THE MANITOBA WATER SERVICES BOARD

CONTRACT NO. M.W.S.B. 1396

**BLACK BEAR WATER CO-OP
WATER TREATMENT PLANT UPGRADES**

ADDENDUM NO. 1

BLACK BEAR WATER CO-OP WTP UPGRADES 2017				
WTP LAYOUT				
SCALE	DATE	PROJECT NUMBER	REVISION	SHEET
N.T.S.	17-07-11	1396		1 of 3

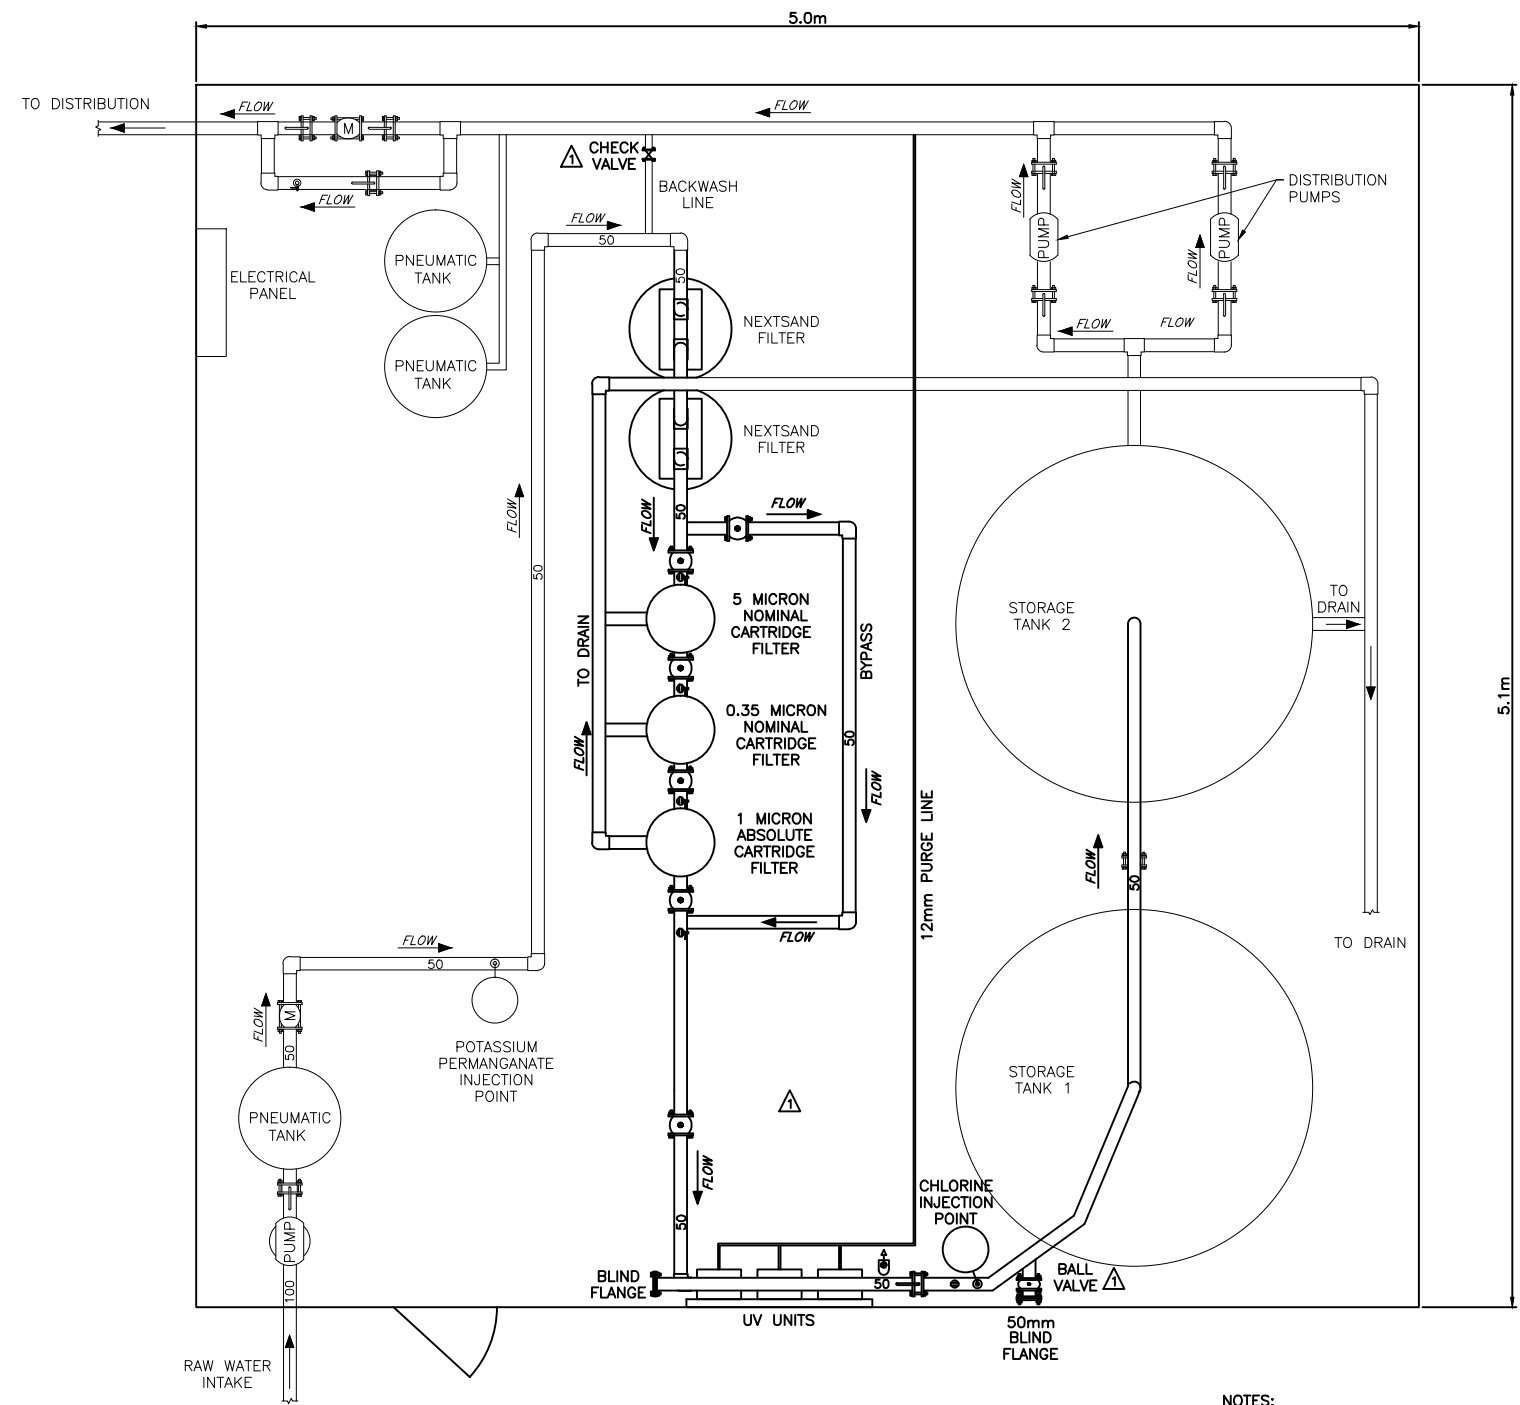
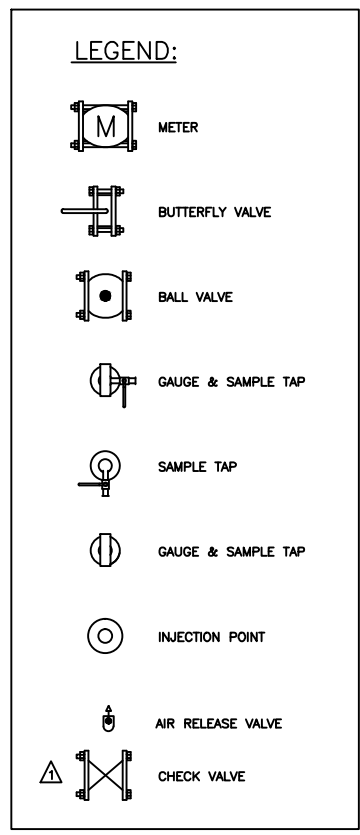
6. See attached revised drawing Page 1 of 3 Addendum 1, 5 micron carbon cartridge filter and by-pass piping removed, ball valve to blind flange and check valve to backwash line added.
7. See attached revised drawing Page 2 of 3 Addendum 1, 5 micron carbon cartridge filter and by-pass piping removed, ball valve to blind flange and check valve to backwash line added.

NO.	DESCRIPTION	BY	DATE
1	REMOVAL OF FILTER & BYPASS AND ADDITION OF VALVES	NLL	17-09-05
